Re: BG 22-104- Christian Co. - New Consolidated High School Schematic Design Review - Response

The following is our response to your Schematic Design Review Dated 1/28/22, item by item:

**EXISTING** TOPO

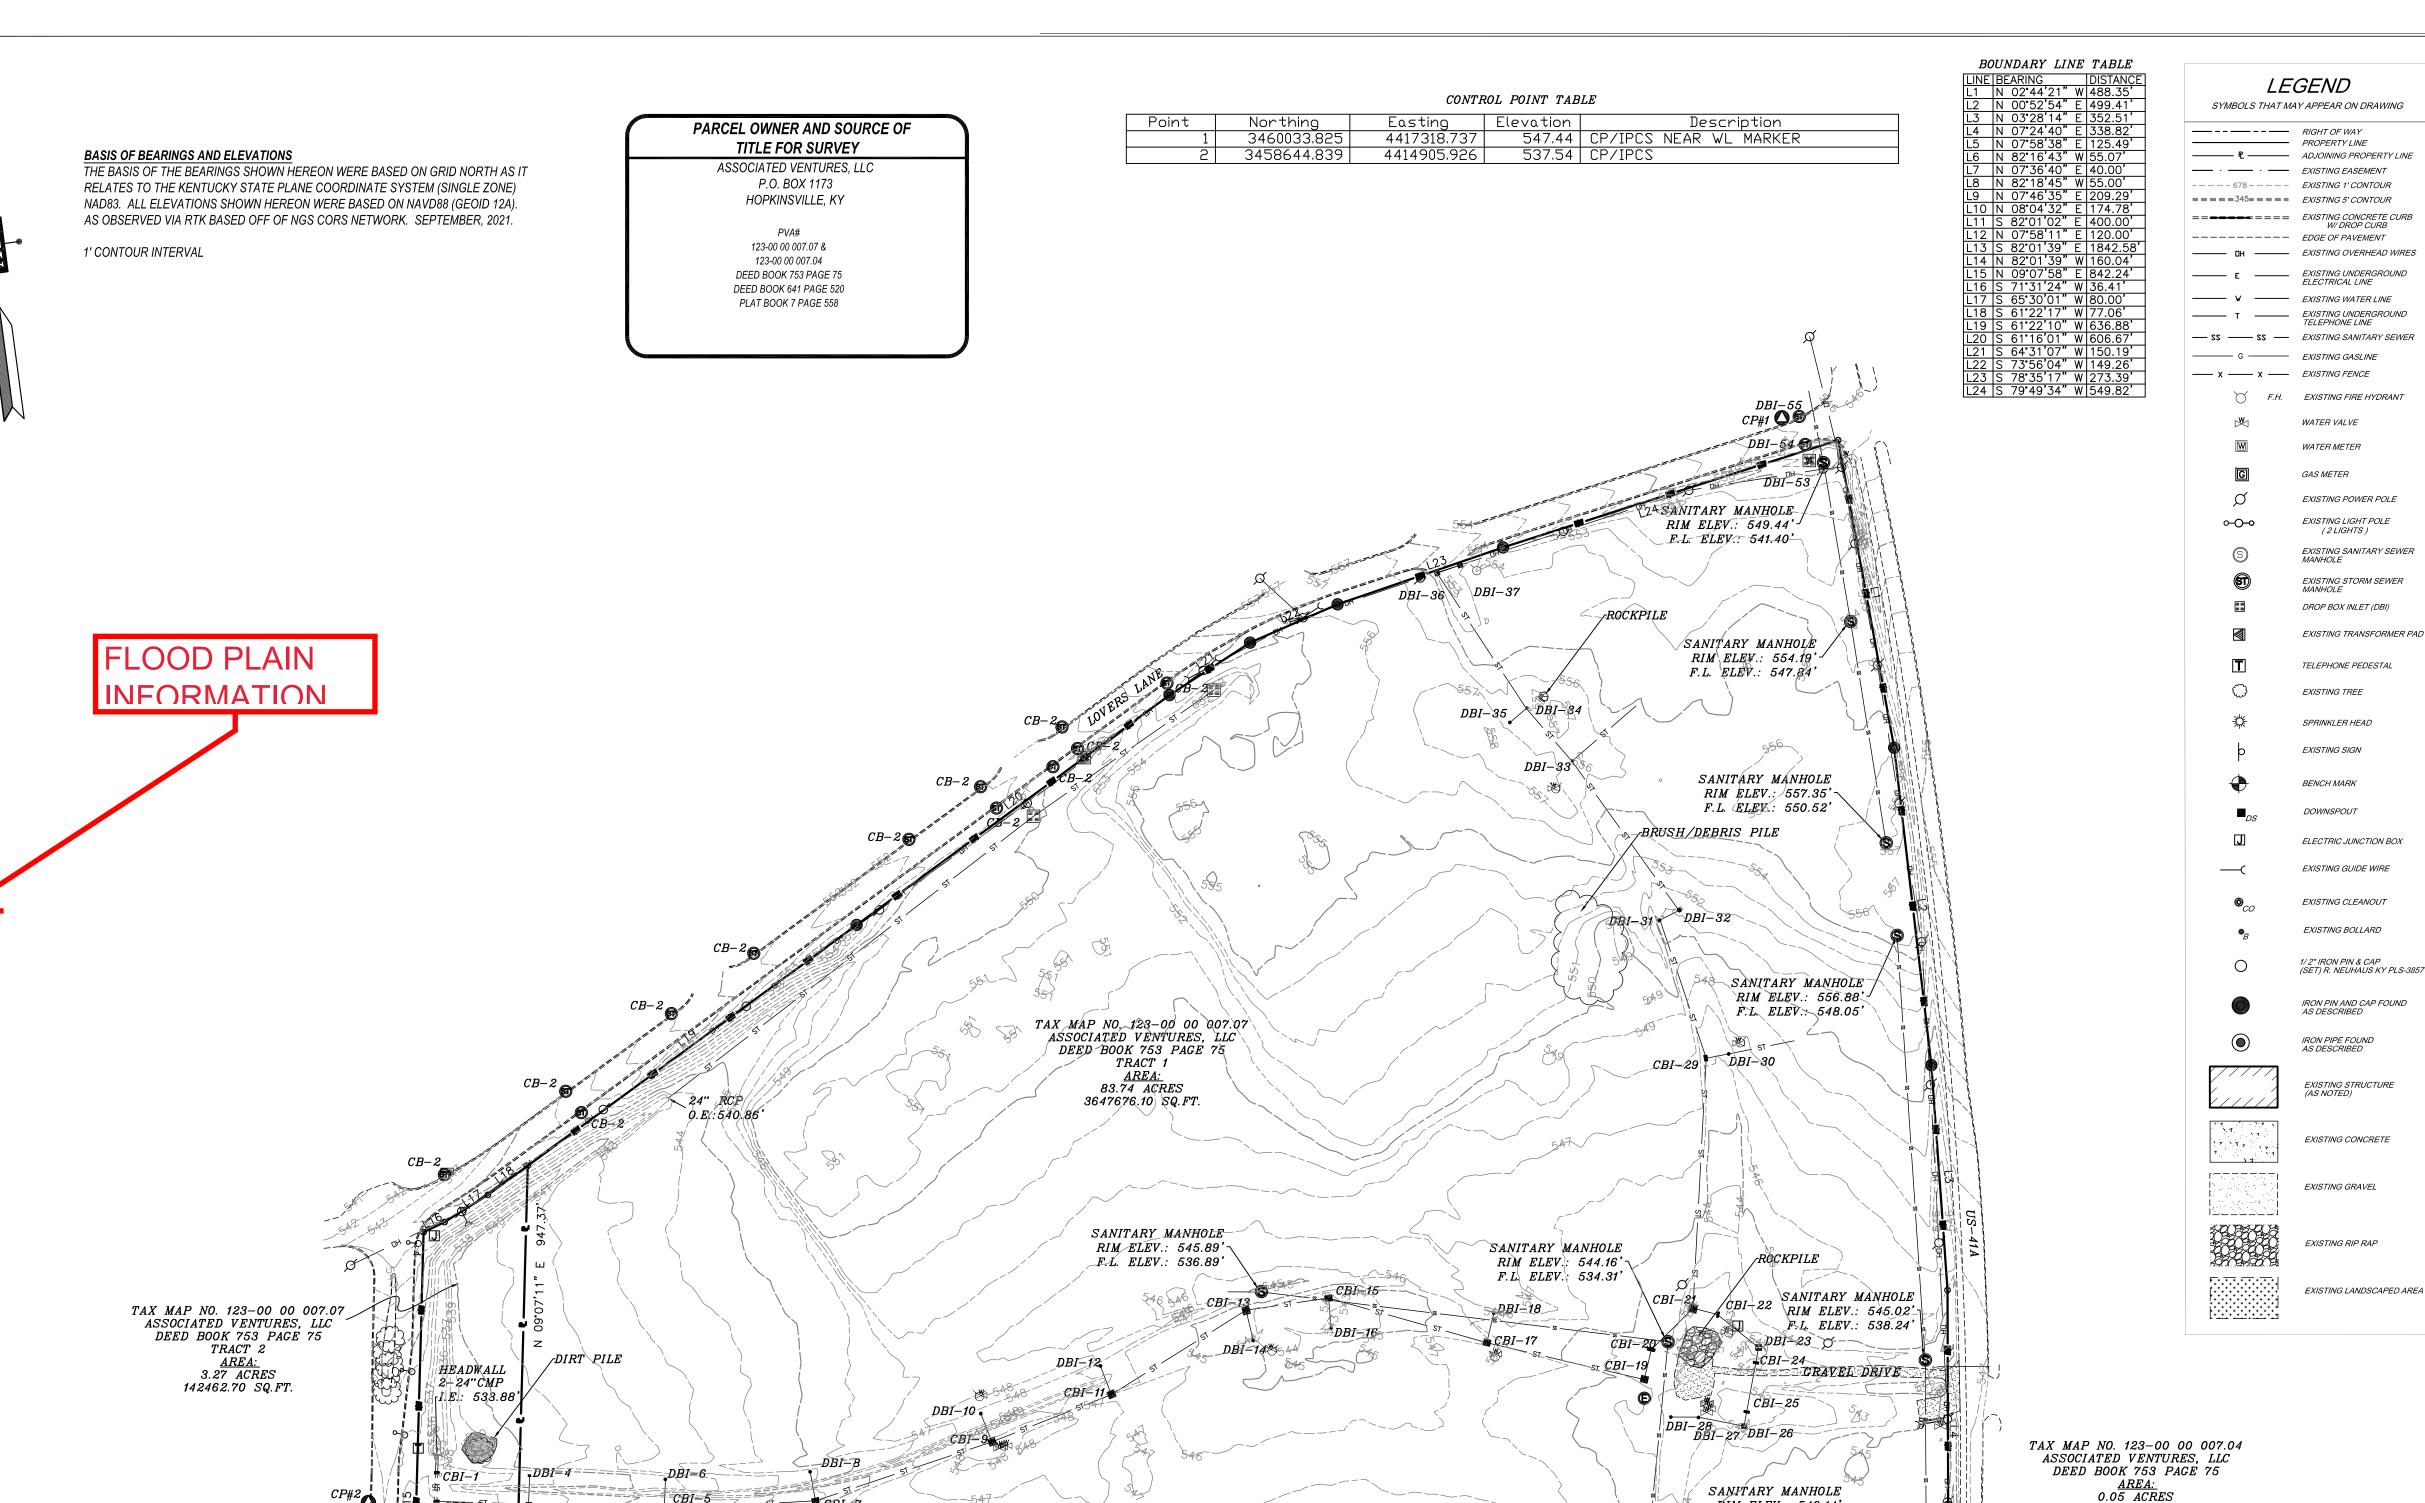
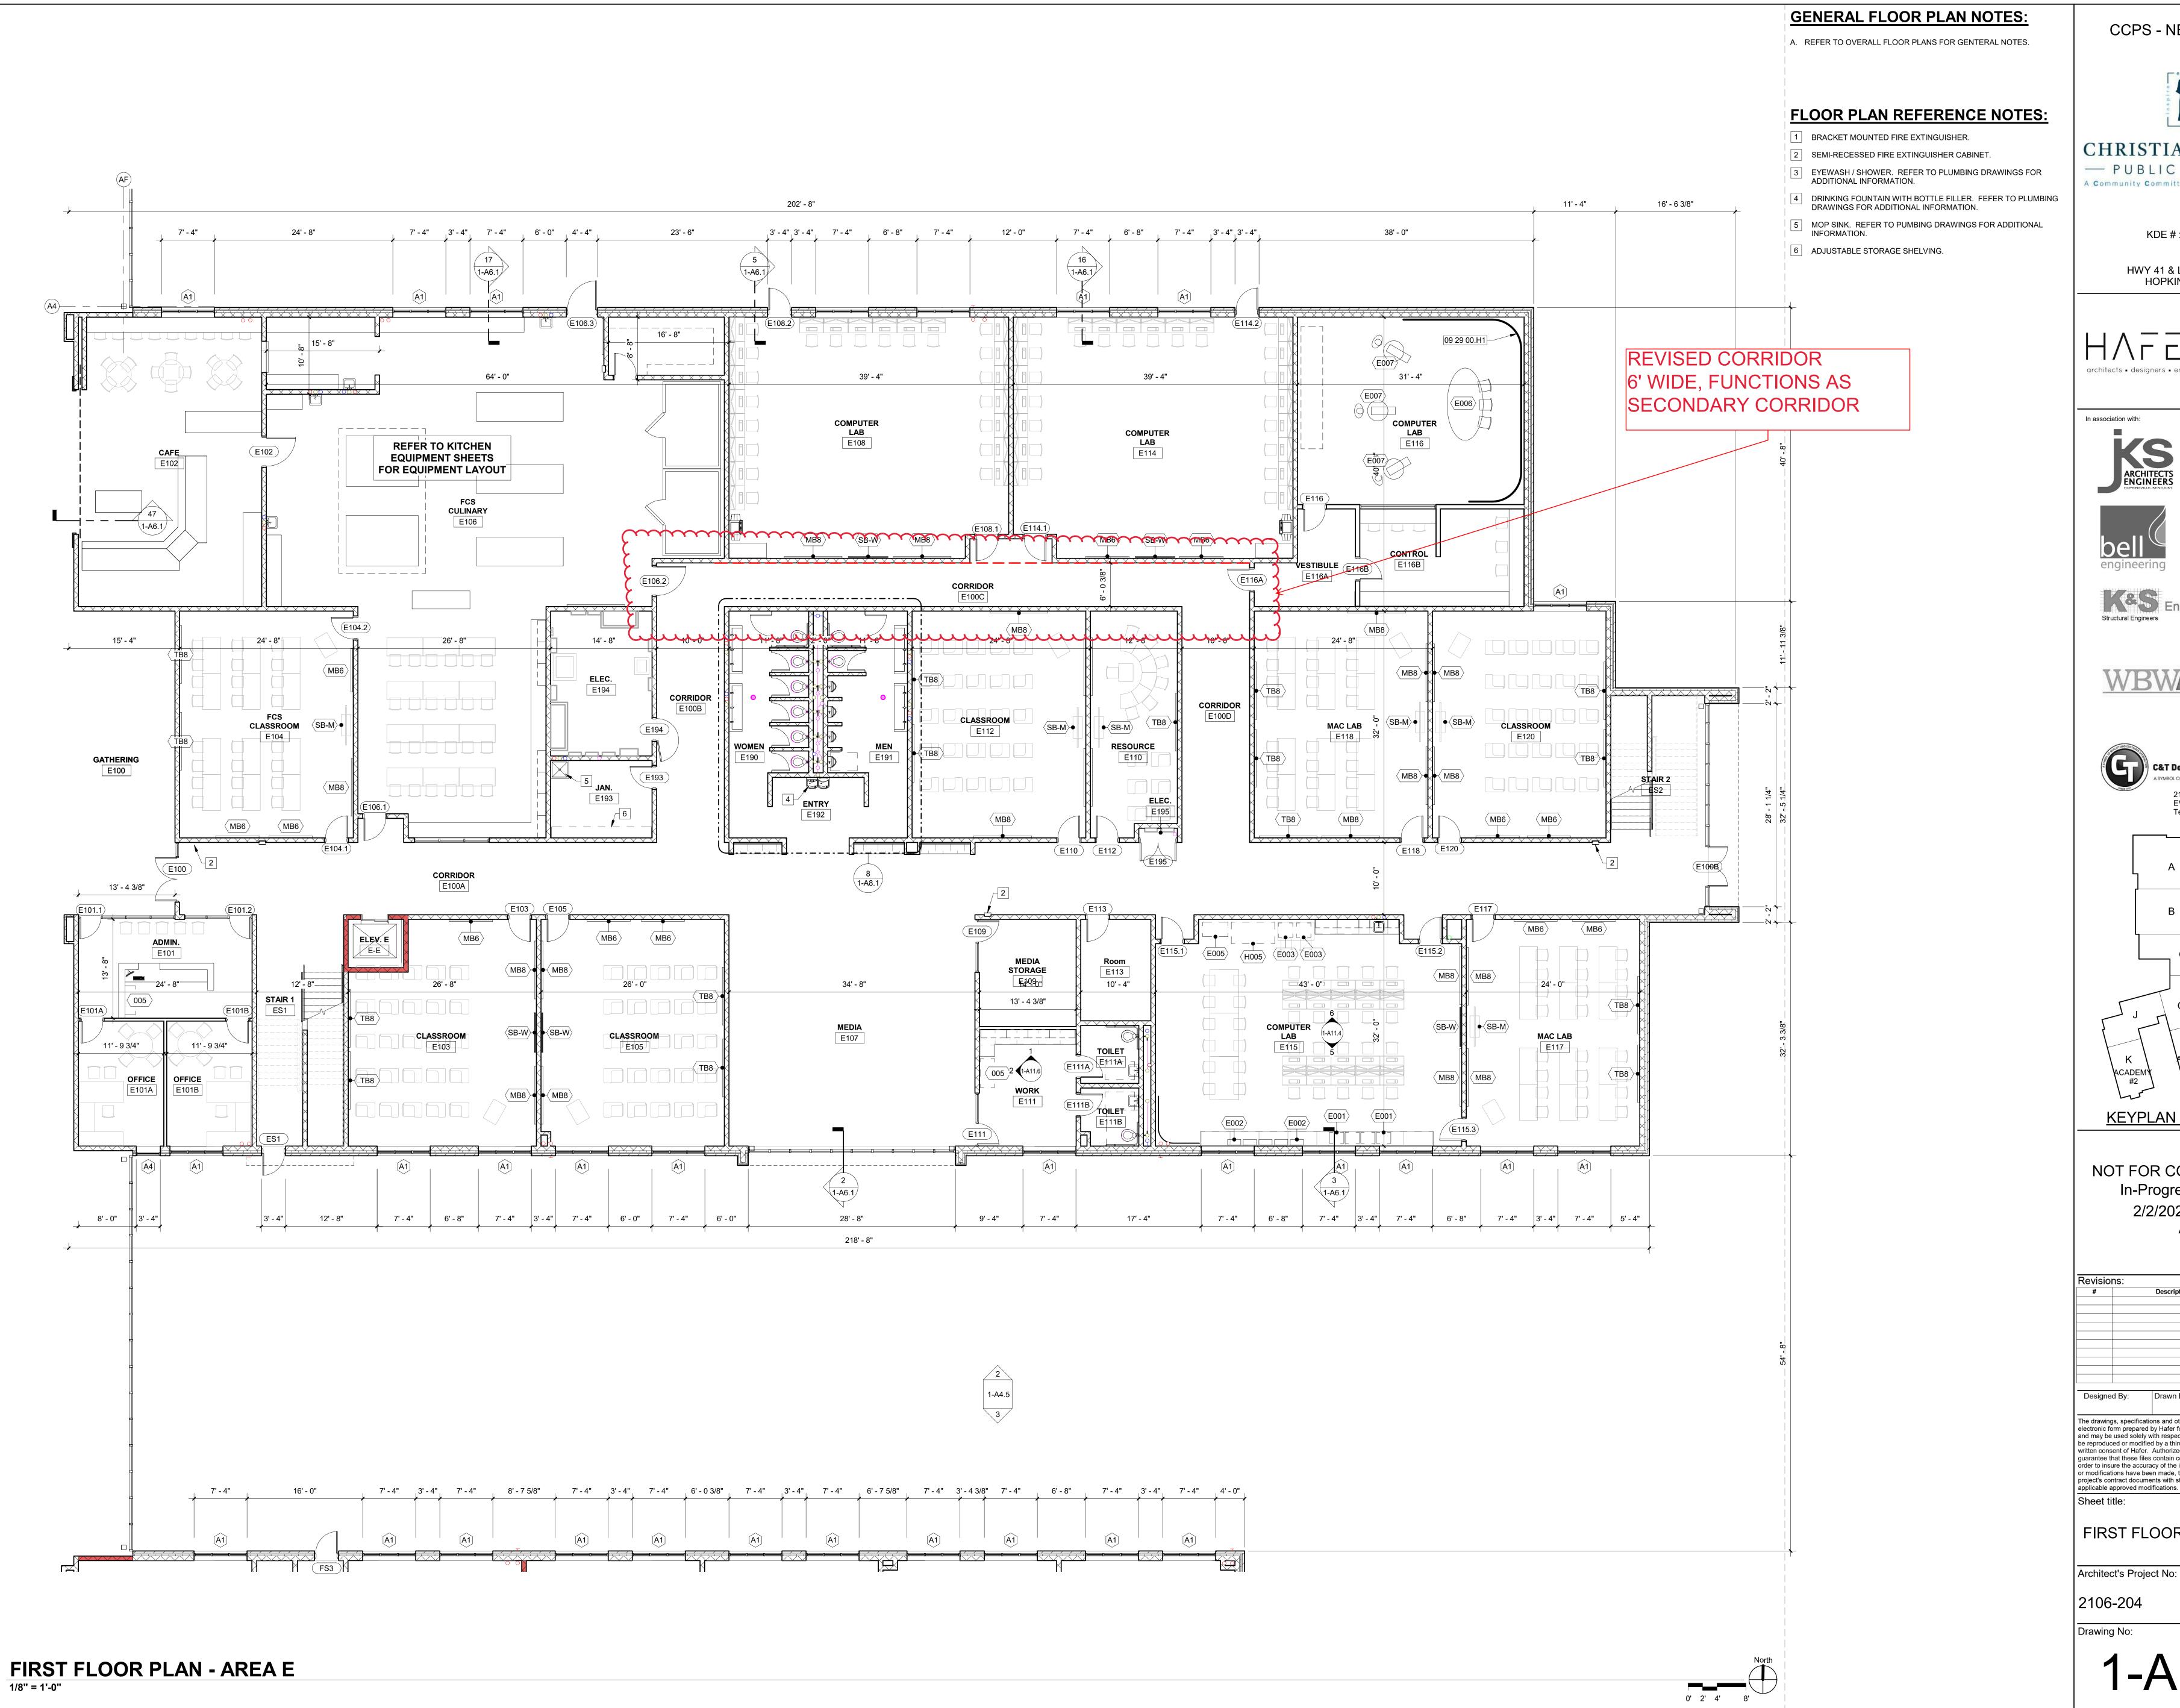
<u>RESPONSE ITEM 2:</u> KDE Regulation 702 KAR4:160 requires the floor elevation for new construction be a minimum of 12 inches above the 100-year flood plain. Confirm the floor elevation of the facility is a minimum of 12 inches above the 100-year flood plain.

RESPONSE: The Proposed High School School Building FFE = 553.0. The lowest elevation on the site is approximately 535.17. This property is not located in a 100-year flood hazard area as indicated by Flood Insurance Rate Map Nos. 21047C0361D, dated April 19, 2019 (attached).

THIS PROPERTY IS NOT LOCATED IN A SPECIAL FLOOD ZONE AS INDICATED BY FLOOD INSURANCE RATE MAPS COMMUNITY PANEL NO. 21047C0361D, EFFECTIVE DATE OF APRIL 19, 2019.

Sheet title: FIRST FLOOR PLAN - AREA E

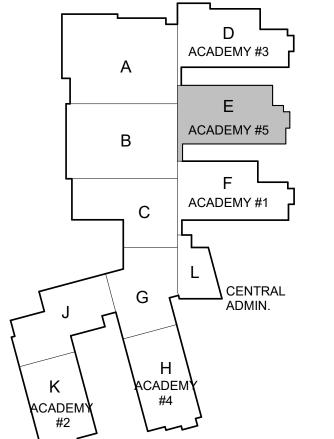
<u>RESPONSE ITEM 4C</u>: Dead end corridors are not allowed pursuant to 702 KAR 4:170 Part 2c.1.1.3. There are 4 instances where this occurs. Correct this condition.

RESPONSE: The two dead end corridors in the Health Academy have been eliminated and are shown resolved in the DD documents that were approved by the B.O.E. The two dead end corridors in the Business Academy have been resolved and are the solution is shown in the attached plan 1-A1.1E.
